## HISTORIC AND DESIGN REVIEW COMMISSION

May 07, 2025

**HDRC CASE NO:** 2025-095  
**ADDRESS:** 122 LEOPOLD  
**LEGAL DESCRIPTION:** NCB 2960 BLK 2 LOT 6&7  
**ZONING:** R-6  
**CITY COUNCIL DIST.:** 1  
**APPLICANT:** Elaine Lutton/Lutton Properties LLC  
**OWNER:** Elaine Lutton/LUTTON PROPERTIES LLC  
**TYPE OF WORK:** Construction of two 1-story rear additions  
**APPLICATION RECEIVED:** April 08, 2025  
**60-DAY REVIEW:** June 07, 2025  
**CASE MANAGER:** Bryan Morales

ROOF PLAN  
50:1/4"  
122 LEOPOLD ST.

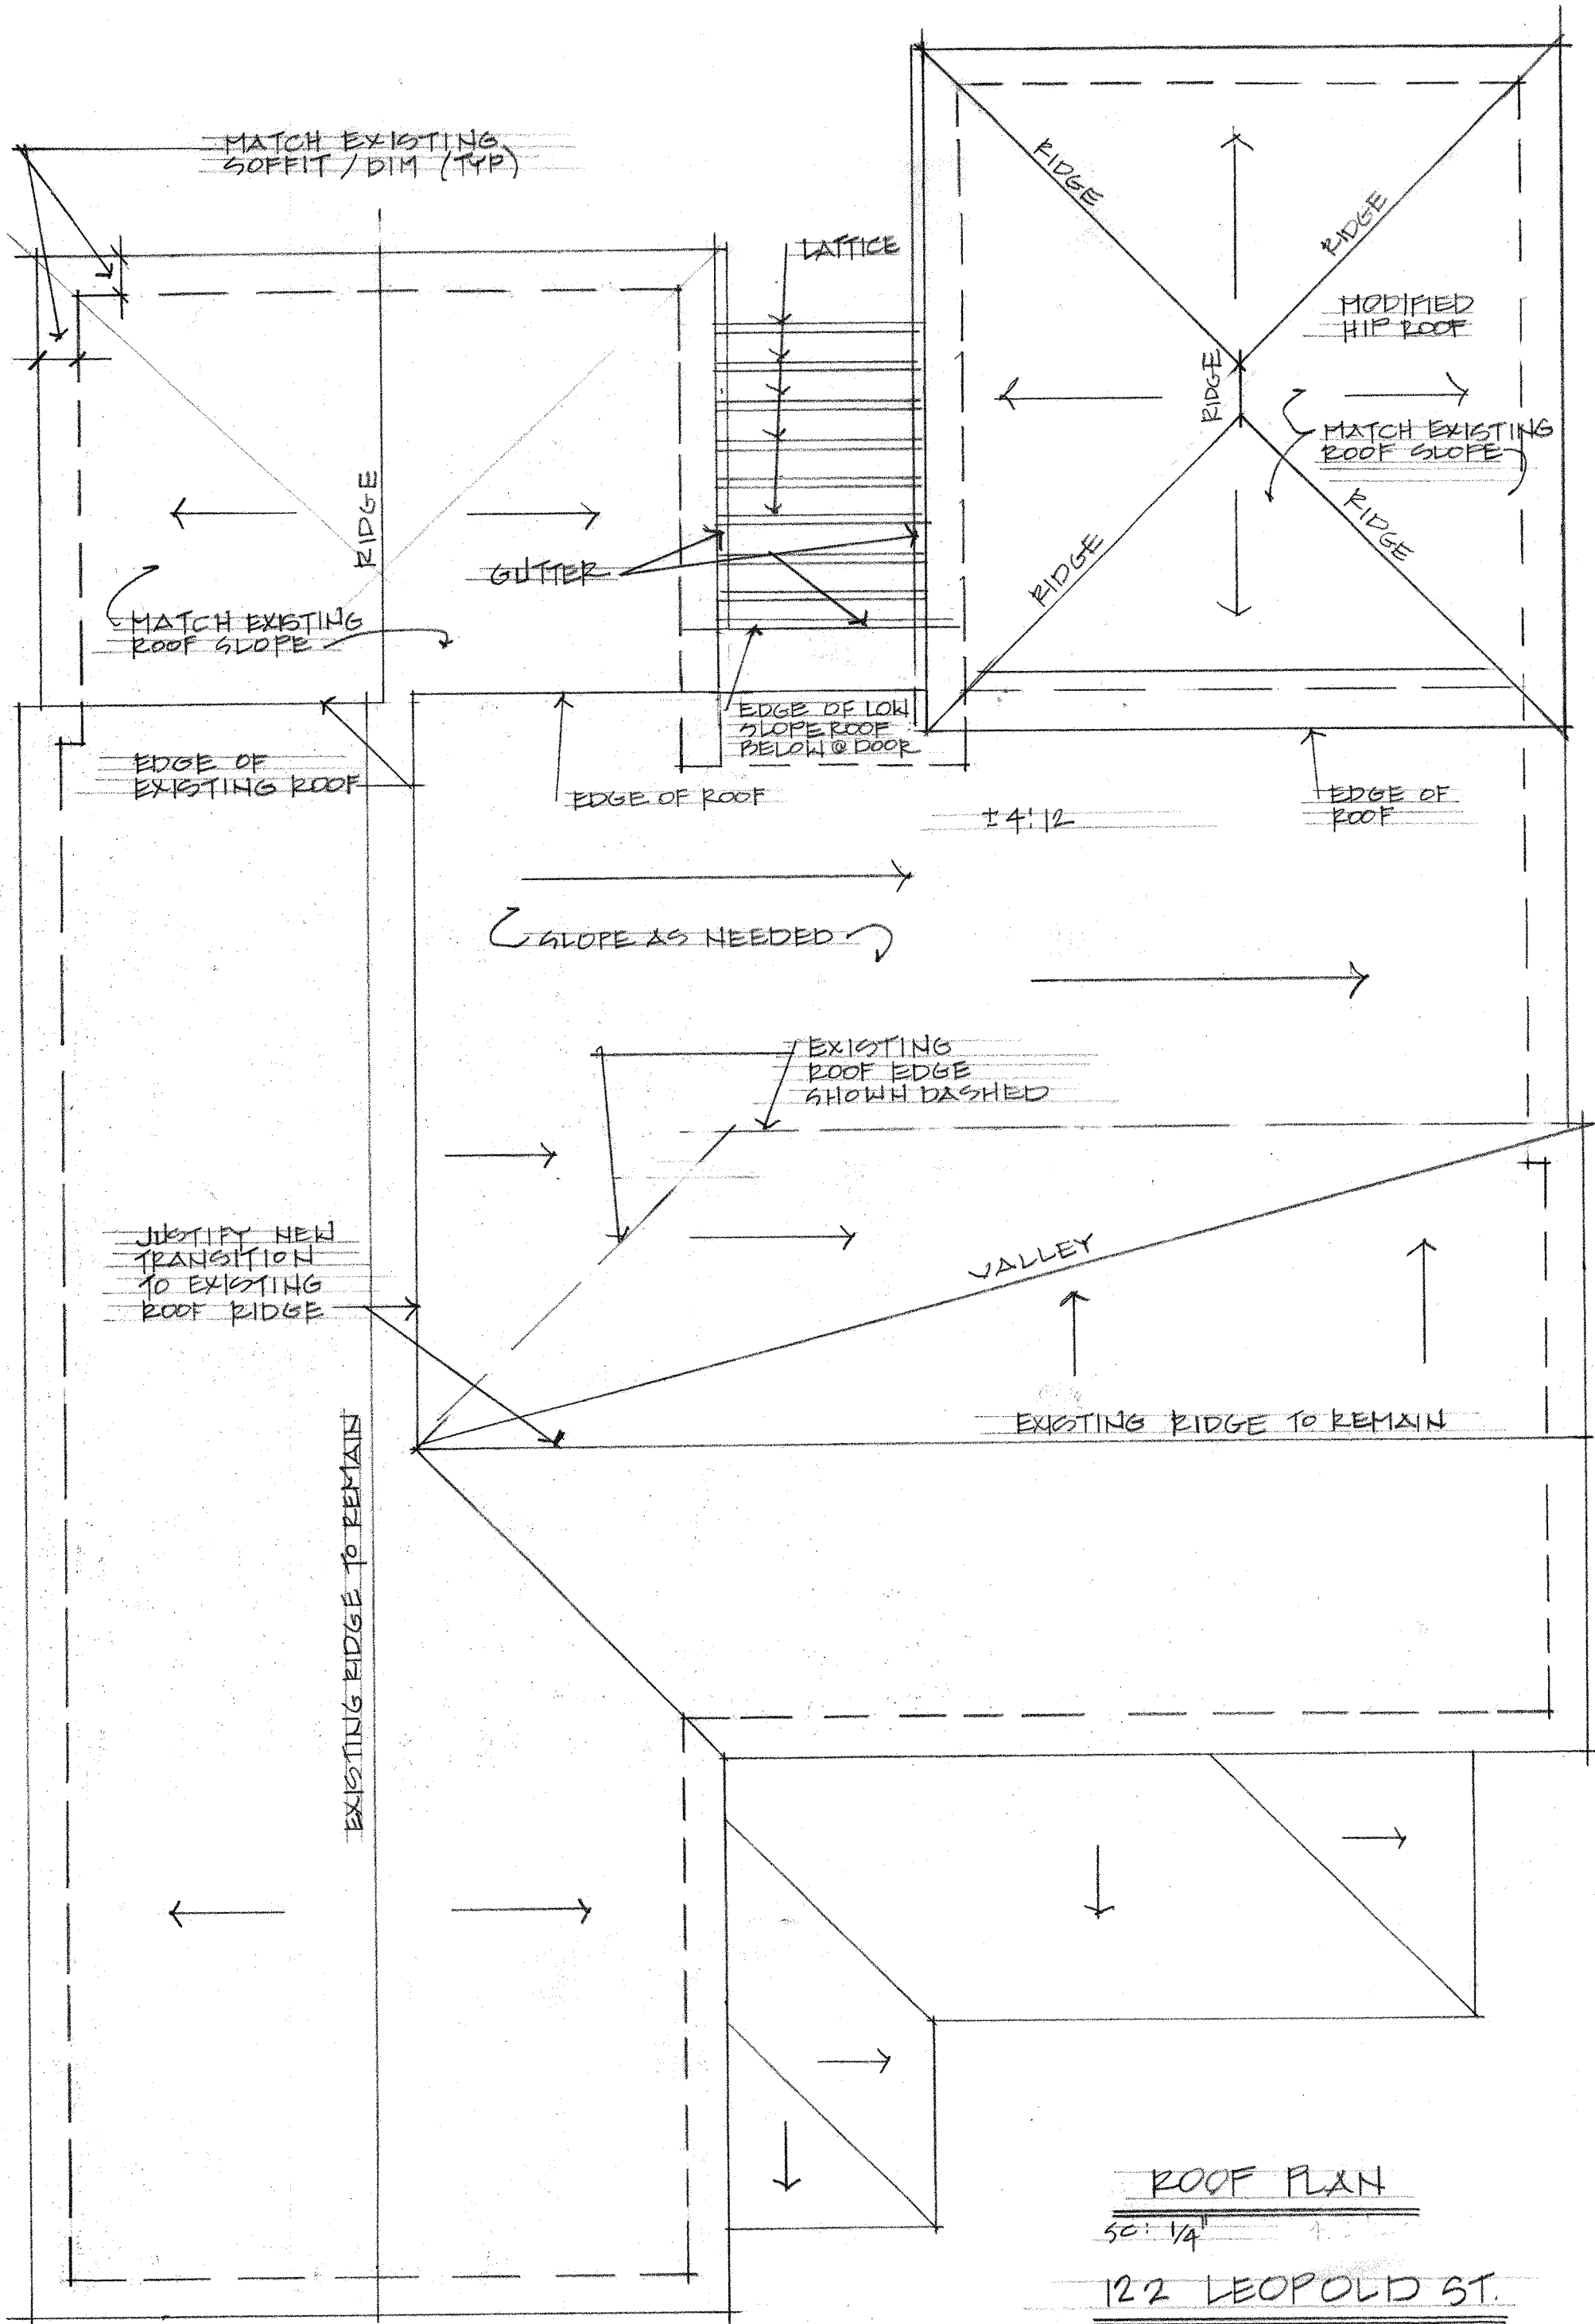
- c. REAR ADDITIONS (ROOF FORM) – The applicant has proposed to construct the southeast rear addition with a rear-facing gable roof and the southwest addition with a hipped roof. In addition, the applicant is proposing to incorporate a shed roof form between the two additions to assist with water runoff. Additions 1.A.iii stipulates that residential additions should utilize a similar roof pitch, form, overhang, and orientation as the historic structure. Staff finds the proposed roof forms generally appropriate.

- d. REAR ADDITIONS (ROOF MATERIAL) – The applicant has proposed to install a standing seam metal roof on the proposed rear additions. Additions 3.A.ii. states to construct new metal roofs in a similar fashion as historic metal roofs. Staff finds the proposed roof material conforms to Guidelines.

- iii. That the applicant installs a standing seam metal roof featuring panels that are 18 to 21 inches wide, seams that are 1 to 2 inches high, a crimped ridge seam, and match the current finish or a standard galvalume finish. Panels should be smooth without striation or corrugation. Ridges are to feature a double-munch or crimped ridge configuration; no vented ridge caps or end caps are allowed. All chimney, flue, and related existing roof details

FLOOR PLAN  
50' 1/4" 4-2-25  
REVISED: 4-8-25  
122 LEOPOLD ST

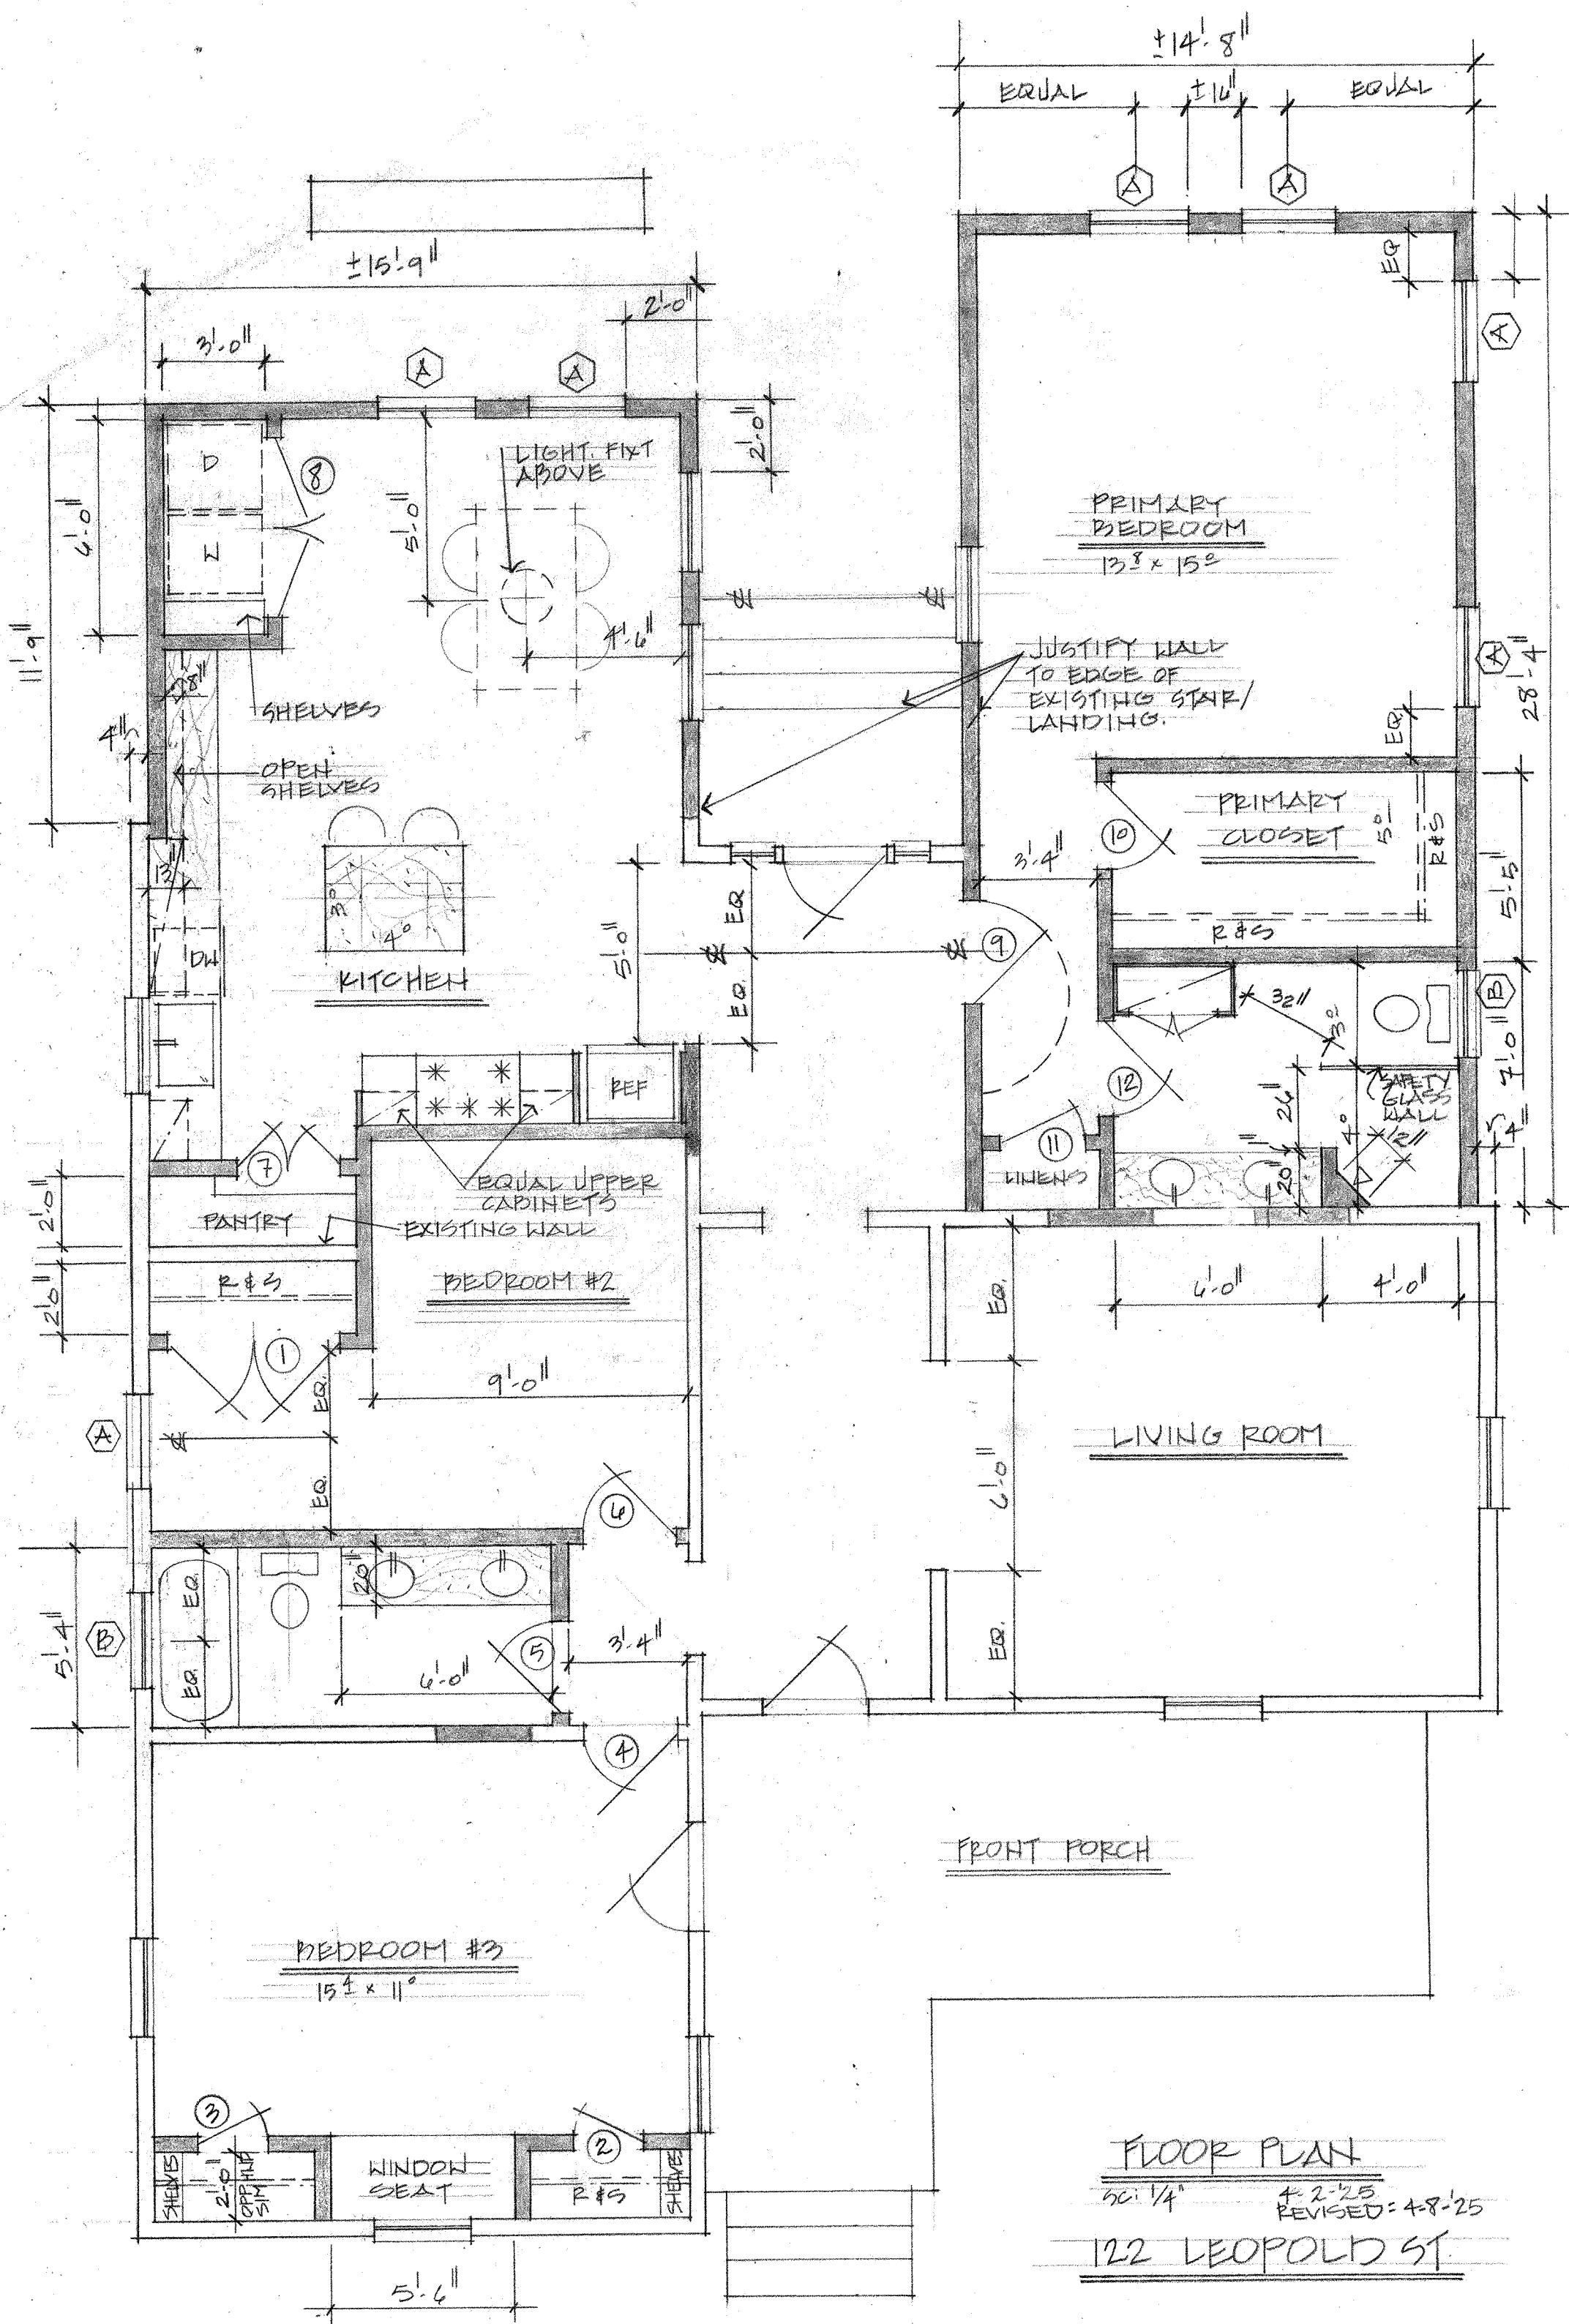
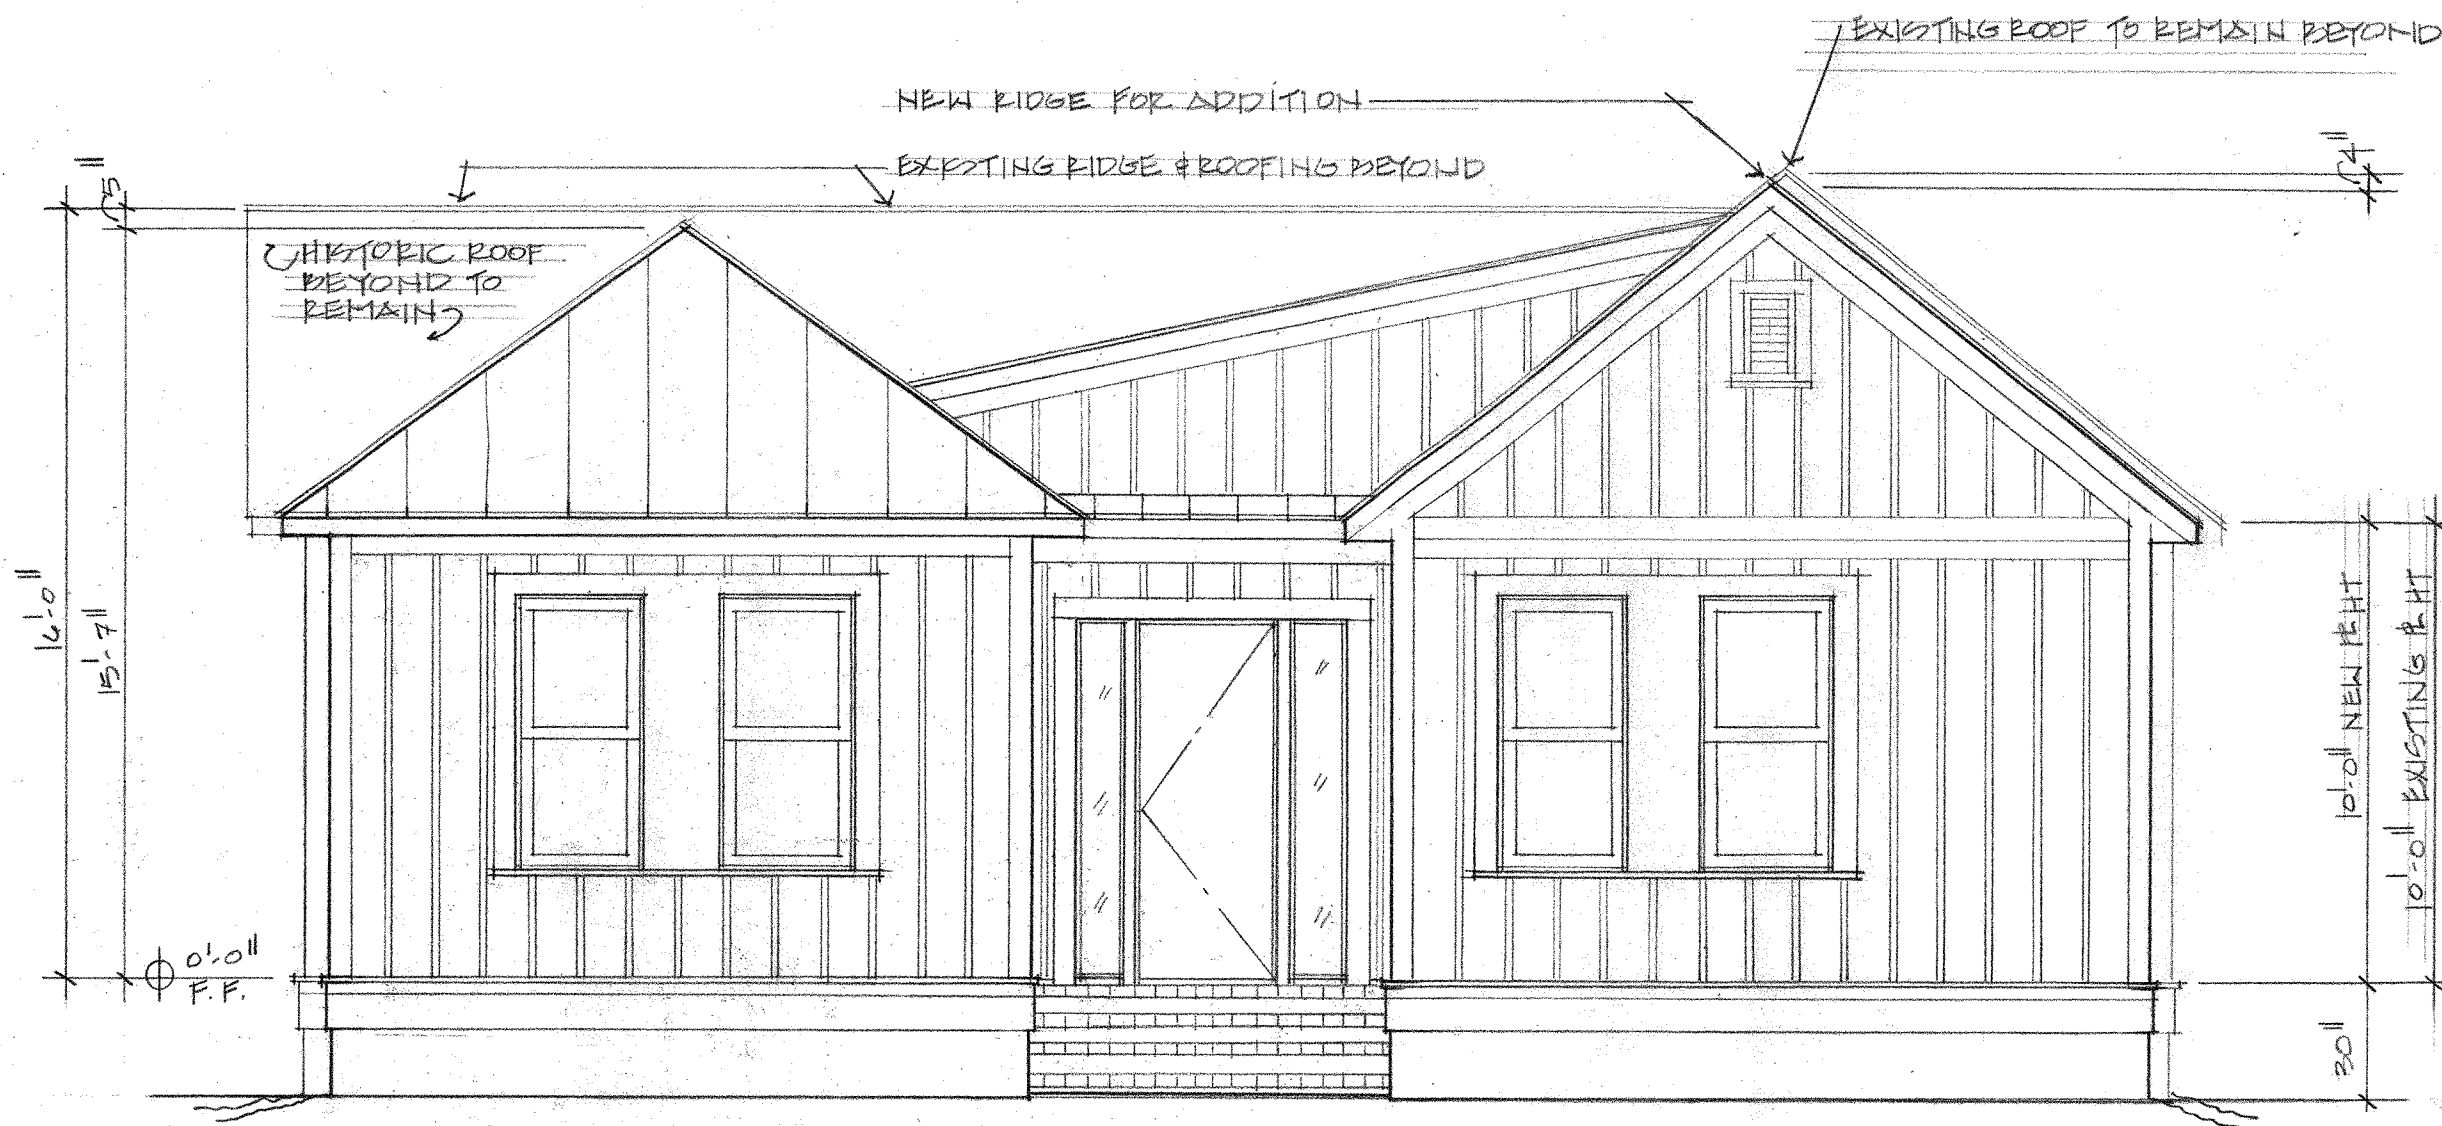
- b. REAR ADDITIONS (MASSING & FOOTPRINT) – The applicant has proposed to replace an existing 1-story rear addition with a new rear addition at the southeast measuring approximately 185 sf and construct a 1-story rear addition at the southwest measuring approximately 233 sf. The existing primary structure is a 1-story, single-family Folk Victorian. Additions 1.B.i stipulates residential additions should be designed to be subordinate to the principal façade of the original structure in terms of scale and mass. Additions 1.B.v. states that generally, the height of new additions should be consistent with the height of the existing structure, the maximum height of new additions should be determined by examining the line-of-sight or visibility from the street, and the addition height should never be so contrasting as to overwhelm or distract from the existing structure. Additions 2.B.iv states the building footprint should respond to the size of the lot. An appropriate yard to building ratio should be maintained for consistency within historic districts. Residential additions should not be so large as to double the existing building footprint, regardless of lot size. Staff finds the proposed rear additions generally appropriate.
